VIRGINIA ELECTRIC AND POWER COMPANY
RICHMOND, VIRGINIA 23261

Serial No. 945
PO/ATV:mmf
Docket No.: 50-280
License No.: DPR-32

REQUESTED RELIEF FROM INSERVICE
INSPECTION AND TESTING REQUIREMENTS
SURRY POWER STATION UNIT NO. 1

REQUESTED RELIEF FROM THE INSERVICE INSPECTION REQUIREMENTS
FOR CLASS 1, 2 and 3 COMPONENTS AS SET FORTH
IN SECTION XI OF THE ASME BOILER AND PRESSURE VESSEL CODE,
1974 EDITION WITH ADDENDA THROUGH THE SUMMER OF 1975
(LAST 40 MONTH PERIOD OF THE FIRST 10 YEAR INTERVAL)

STEAM GENERATOR PRIMARY NOZZLE SAFE-END TO PIPE WELD
CONFIGURATION

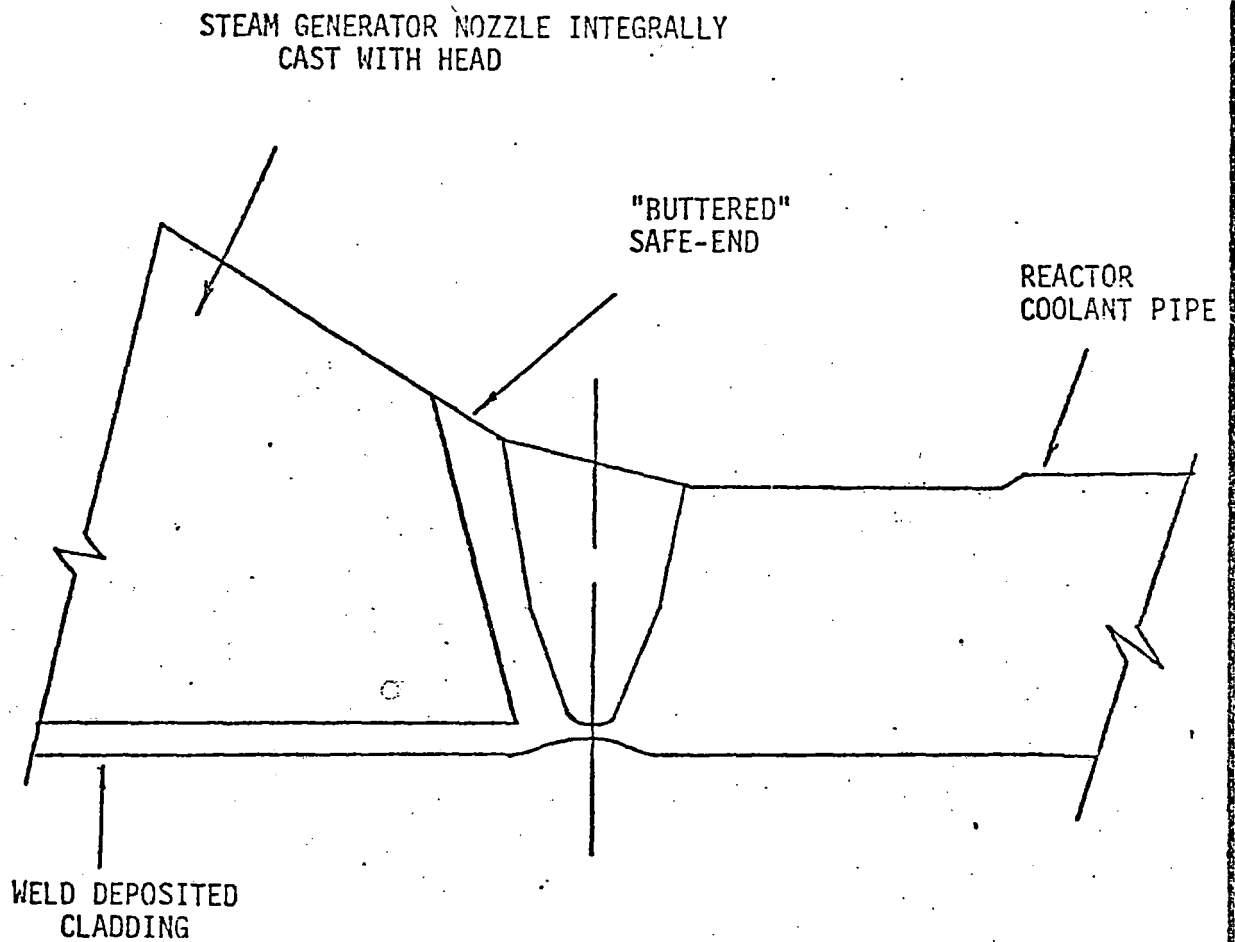
8. Examinations of the steam generator primary nozzle to safe-end and safe-end to pipe weld is limited both by the nozzle geometry and surface condition and the limited surface preparation on the pipe side of the weld. The surface on the pipe side of the weld, which is a cast elbow, is machined for a distance of approximately three inches from the edge of the weld. Ultrasonic examination is limited to this from the edge of the weld. Examinations can be performed on the surface of the weld but are severely limited from the nozzle side by the rough, as cast surface. Surface examination can be performed on one hundred percent of the weld and the base metal on the pipe side. The configuration is shown in Figure 1.

FIGURE 2

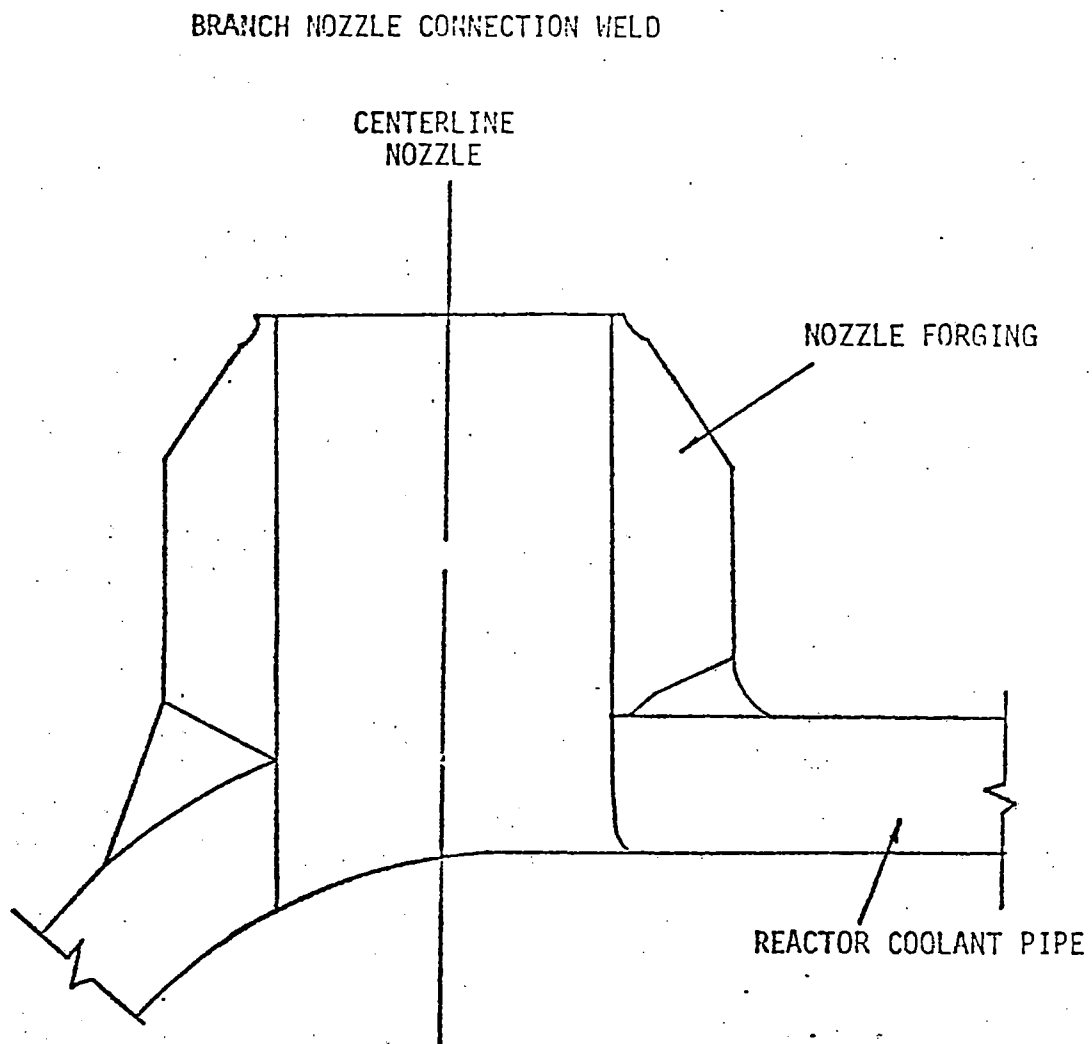
11. The configuration of the reactor coolant branch nozzle connection welds is as shown in Figure 2. Ultrasonic examinations cannot be performed on the surface of the weld. Examinations will be performed to the extent practical from the pipe and nozzle adjacent to the weld. Surface examination will be performed to supplement this volumetric examination.

RESIDUAL HEAT REMOVAL HEAT EXCHANGER
NOZZLE TO VESSEL CONFIGURATION

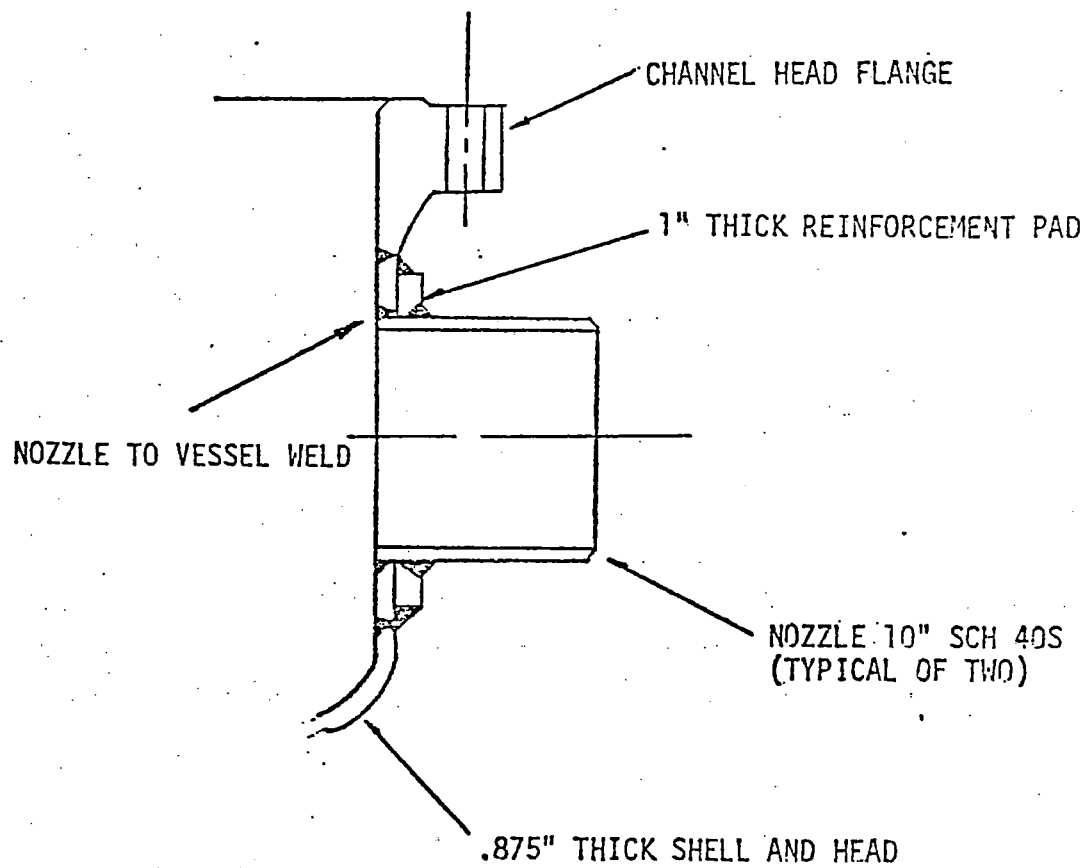
1. There are no items in this category on this component in the Surry Unit 1 Class 2 systems.
2. The nozzle to vessel welds of the residual heat exchangers are covered by 1" thick by 3" wide reinforcement pad as shown in Figure 3. These welds are not accessible for examination by volumetric or surface methods. The area will be subject to visual examination for evidence of leakage during system pressure tests.

Figure 4

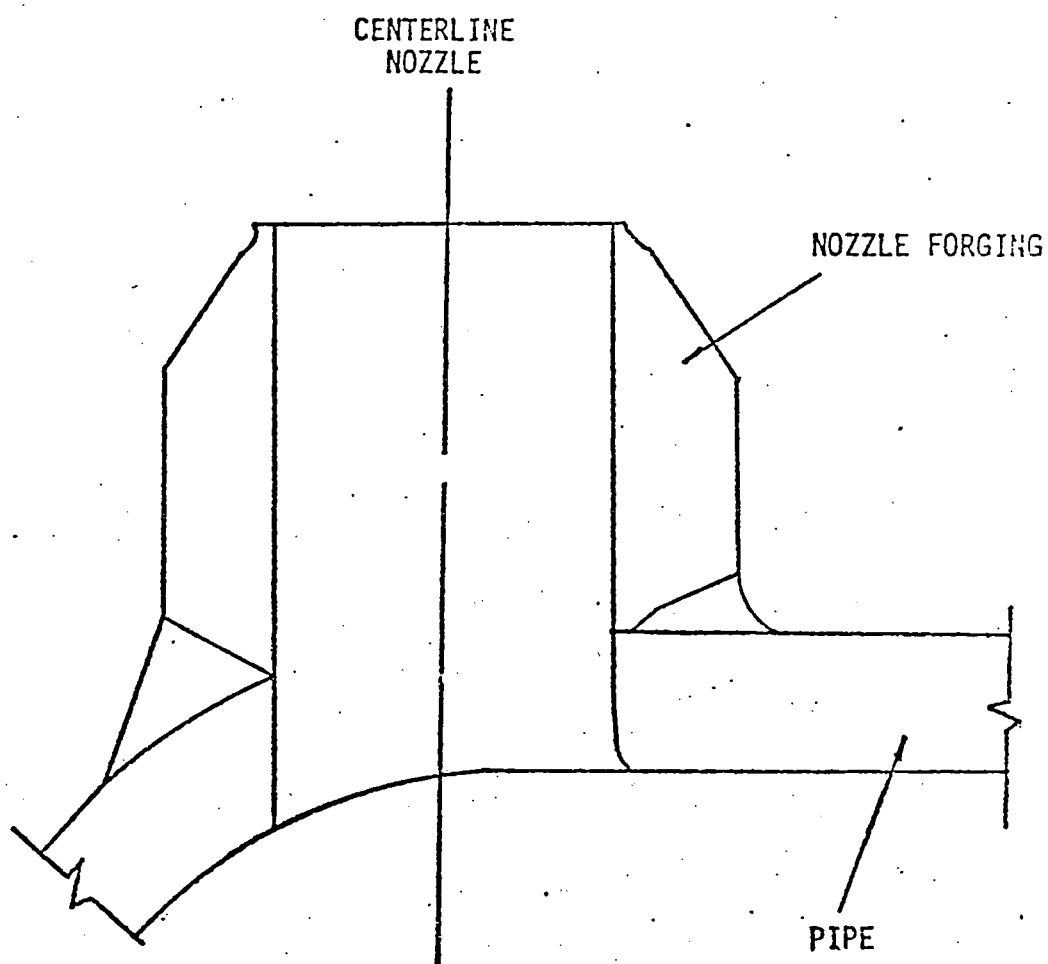
- (viii) 12", 10", 6" RHR weld 10
 - (ix) 10" SIS; weld 9
 - (x) 10", 6" SIS welds 6 and 14
12. The configuration of typical branch pipe welds is shown in Figure 4. Ultrasonic examinations cannot be performed on the surface of the weld. Examinations will be performed to the extent practical from the pipe and nozzle surfaces adjacent to the weld. Surface examination of the weld will be performed to supplement the volumetric examination.
